ARLINGTON COUNTY, VIRGINIA

**County Board Agenda Item
Meeting of April 16, 2011**

- SUBJECTS:**
- A. Adoption of the East Falls Church Area Plan;
 - B. GP-321-11-1 Adoption of General Land Use Plan (“GLUP”) Amendments for the East Falls Church area; and
 - C. Adoption of Amendments to the Master Transportation Plan (“MTP”) Map and the Bicycle Element of the MTP.

GP-321-11-1 General Land Use Plan Amendments

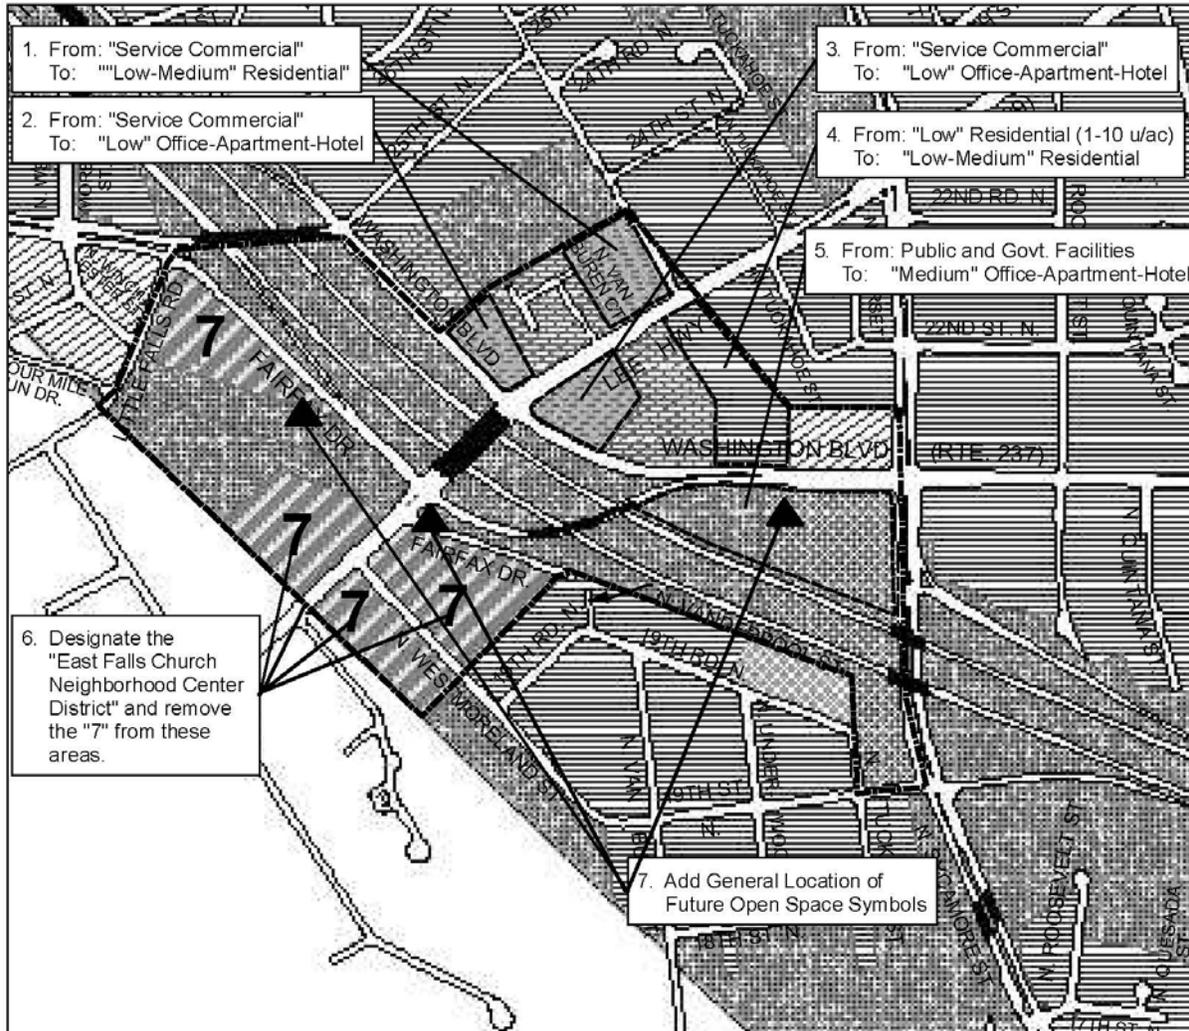
7. ~~Within the area shown as “Low” Office Apartment Hotel, building heights shall be limited to a maximum of 65 feet along Lee Highway and Fairfax Drive, tapering to a maximum of 35 feet along frontages adjacent to residential neighborhoods. On April 16, 2011, this area was designated as the “East Falls Church Neighborhood Center District.~~

Attachment 5. Recommended Bikeway Network Map

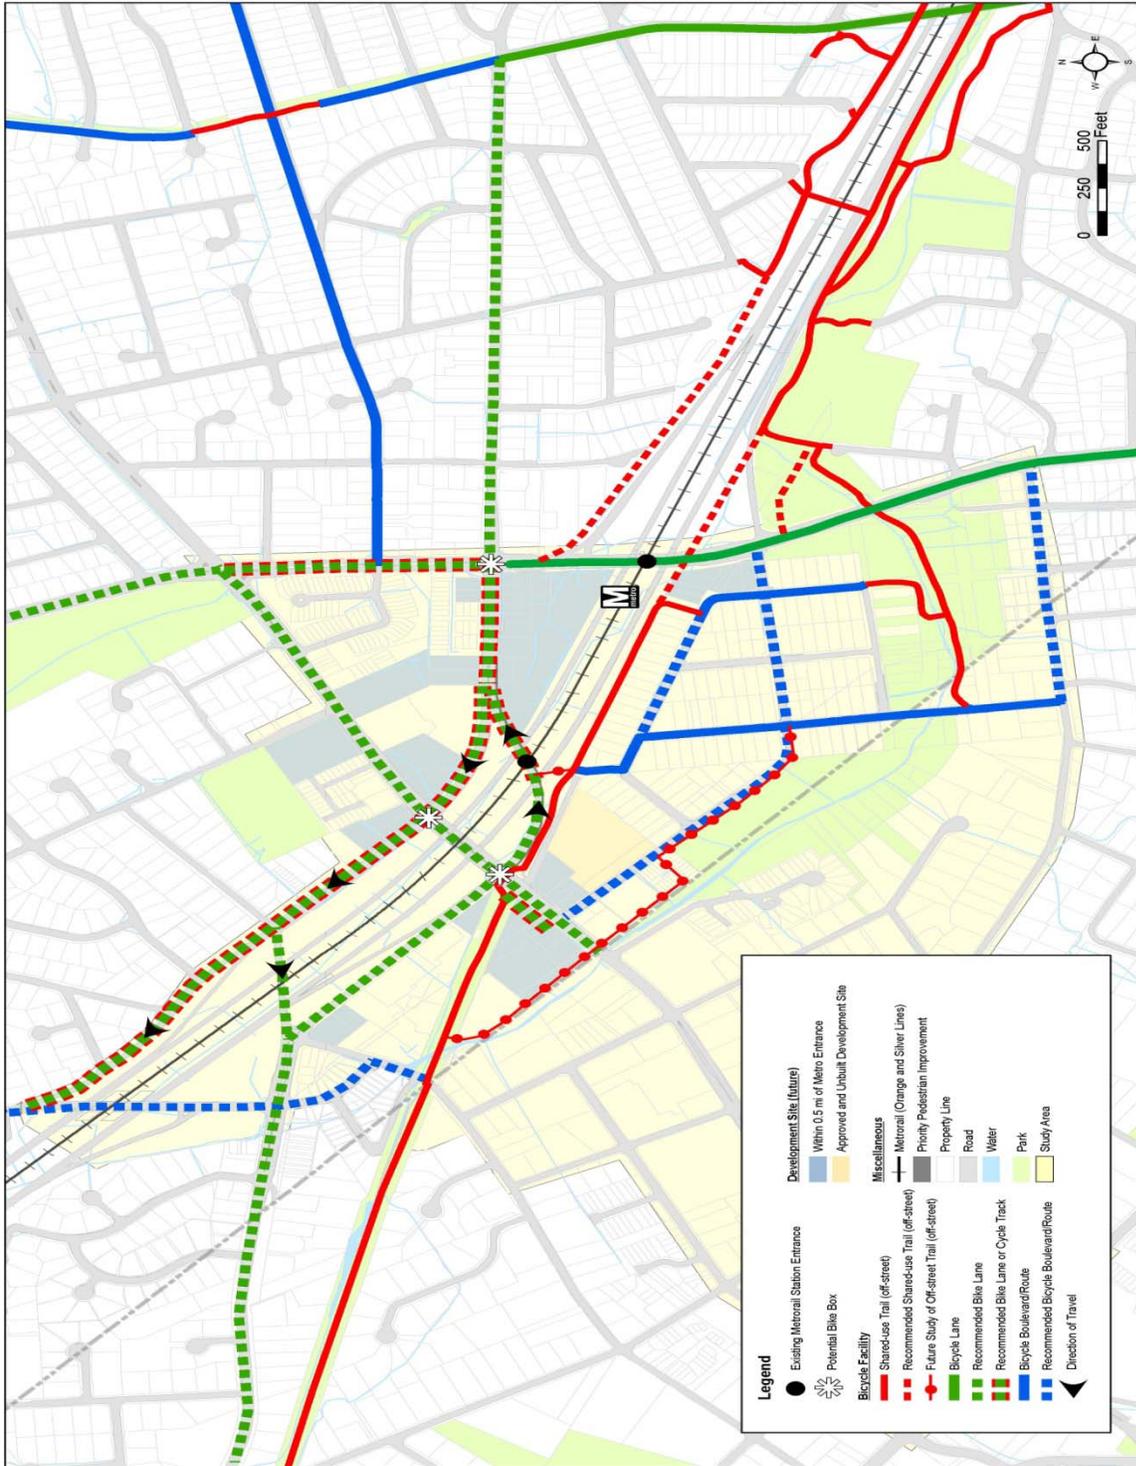
The MTP Bicycle Element and the MTP Map should be amended, in accordance with the Recommended Bikeway Network Map (Attachment 5), to show planned bicycle lanes or sharrows along: Lee Highway (west of Sycamore Street), Sycamore Street (north of Lee Highway), Westmoreland Street (north of Washington Boulevard), 25th Street North (between Washington Boulevard and Fairfax Drive), Fairfax Drive (between Lee Highway and the County line) and Washington Boulevard (west of John Marshall Drive). In addition, the MTP Map and Bicycle Element should be amended to add bicycle routes to the following East Falls Church area streets: 16th Street North (between Sycamore Street and the County line), Westmoreland Street (between Lee Highway and North Van Buren Street), 19th Street North (between Van Buren Street and Sycamore Street), and 19th Road North (between Tuckahoe Street and Van Buren Street).
